Application for licence amendment

Licence number	L8121/2003/2
Licence holder	BGC (Australia) Pty Ltd
ACN	005 736 005
File number	DER2012/004657
Premises	<p>BGC Cement 24 Beard Street NAVAL BASE WA 6165</p> <p>Legal description – Lot 32 on Diagram 44929, Lot 33 on Diagram 55120, Lot 144 on Plan 3638 and Lot 145 on Plan 3638</p>
Date of report	25 January 2021
Decision	Revised licence granted

Figure 1: BGC Cement Naval Base – site plan of blending plant and silos (A)

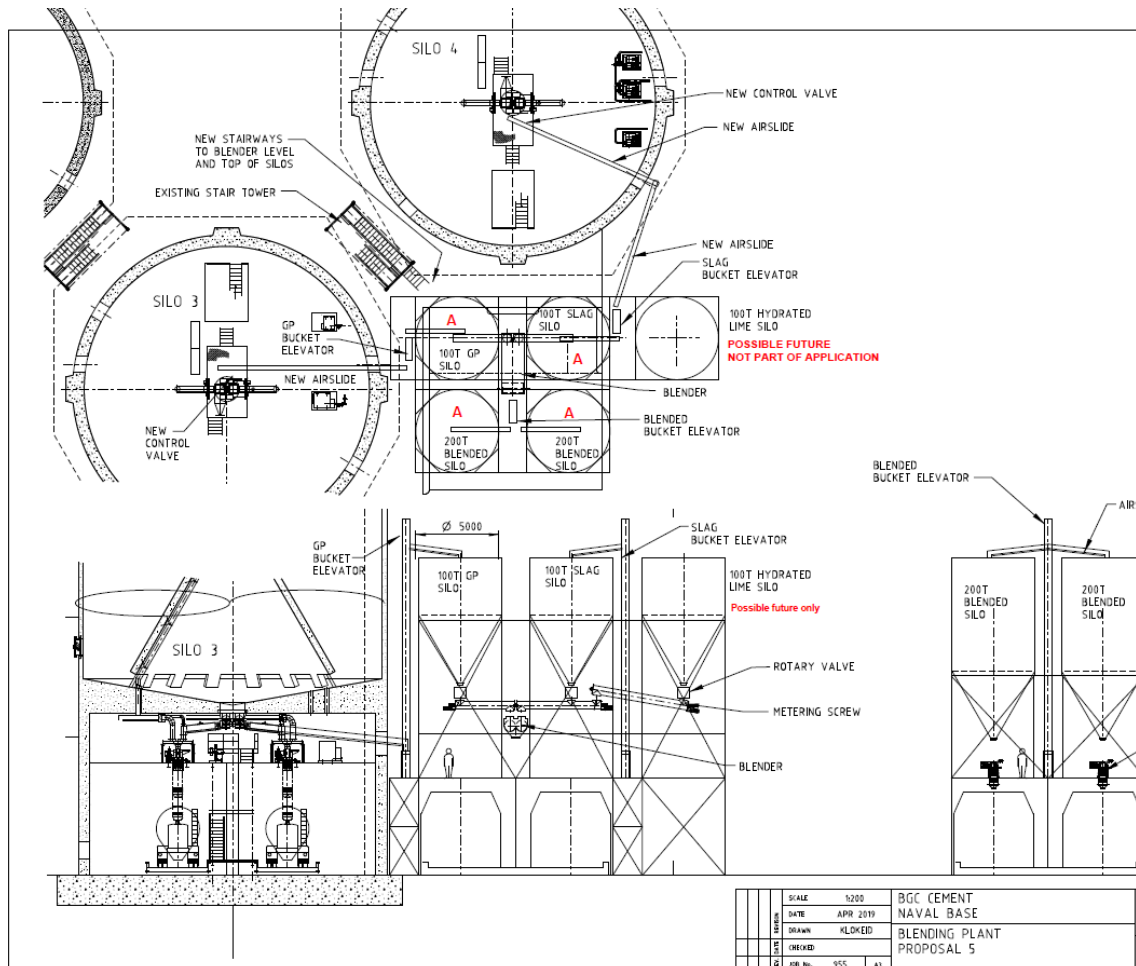
Condition	Summary of licence holder's comment	Department's response
Table 1	Please also include an additional line for "Mill Dust Collectors" x 4. These are shown on the Figure provided in the original application and should also be added to Schedule 1, Figure 2 on the Licence.	These additional dust collectors have been added to Table 1 of the Licence and Figure 2 has been updated.
Table 2	Blending plant: 2 x 100 tonnes silos, blender and associated conveyor belts and bucket elevators Please amend wording for technical accuracy: "blender and associated enclosed screw conveyors and bucket elevators"	The department accepts the proposed change to the wording in Table 2.
Table 2	2 x 200 tonnes silo (blended product) Please amend to capture minor design change: 2 x 300 tonne silo (blended product)	The department does not consider that the increase to capacity of the silo will involve an increase to production or emissions and agrees to this change in the final amended Licence.
